Product Change Notification (PCN)

| PCN Number | 506286 | Date Issued | December 21, 2018 |
| Reason for Change | Change to Product | | |

Before change

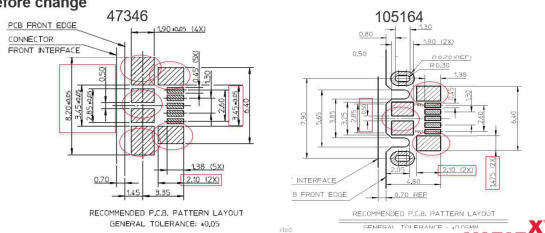
- Optimize recommended PCB layout of micro USB 47346 and 105164 series to reduce the potential risk of soldering open issue
- Qualification data and samples available upon request
- Product Impact
 - No change to product function.
 - Part Number Impact: 47346-0001
 - 105164-0001

After change

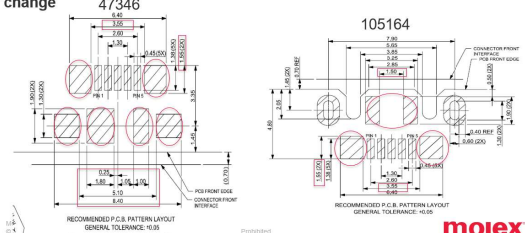
- Optimize recommended PCB layout of micro USB 47346 and 105164 series to reduce the potential risk of soldering open issue
- Qualification data and samples available upon request
- Product Impact
 - No change to product function.
 - Part Number Impact: 47346-0001
 - 105164-0001
